Access Compliance Report

Public Rights-of-Way

(Curb Ramps)

Intersection ID: 31934	Main Street: STEELE_CREEK_RD	Cross Street: BRANCH_BEND_LN	Location: SW
ADA ID: 9195231D99DD	Ramp Type: BlendTrans2	Initial Pass/Fail: Fail	Overall Compliance: No
Severity Score: 12.5			
Codes/Mitigation Info/Possible Solution		Field Measurements/Component Compliance

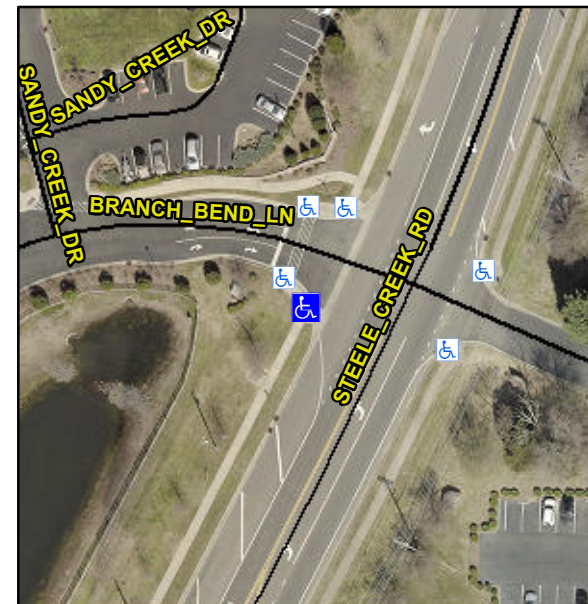
Remove & Replace Curb Ramp With Two New Directional Ramps or Equivalent.

R304.5.3

Compliance	Description	Data	Compliance	Description	Data
N/A	Ramp Length (in)	74.0	Yes	BlendTrans Slope (%)	2.2
Yes	Ramp Width (in)	60.0	No	BlendTrans XSlope (%)	5.1
N/A	Flare Type LT	N/A	N/A	Flare Type RT	N/A
N/A	Flare Slope LT (%)	N/A	N/A	Flare Slope RT (%)	N/A
N/A	Flare Traversable LT?	N/A	N/A	Flare Traversable RT?	N/A
N/A	Landing Length (in)	N/A	N/A	DWS Provided?	N/A
N/A	Landing Width (in)	N/A	N/A	DWS Contrast?	N/A
N/A	Landing Slope (%)	N/A	N/A	DWS Length (in)	N/A
N/A	Landing X Slope (%)	N/A	N/A	DWS Full Width?	N/A
N/A	Landing Curb? (Y/N)	N/A	N/A	DWS Offset (in)	N/A
N/A	Shared Landing?	N/A			
N/A	Gutter Ponding?	N/A	N/A	Gutter Slope (%)	N/A
N/A	Gutter Lip Ht (in)	N/A	N/A	Gutter X Slope (%)	N/A
N/A	Painted X Walk1?	No	N/A	Painted X Walk2?	N/A
	X Walk 1 Direction	To SE		X Walk 2 Direction	N/A
	X Walk 1 Width (in)	N/A		X Walk 2 Width (in)	N/A
	X Walk 1 Slope (%)	1.1		X Walk 2 Slope (%)	N/A
	X Walk 1 X Slope (%)	1.3		X Walk 2 X Slope (%)	N/A
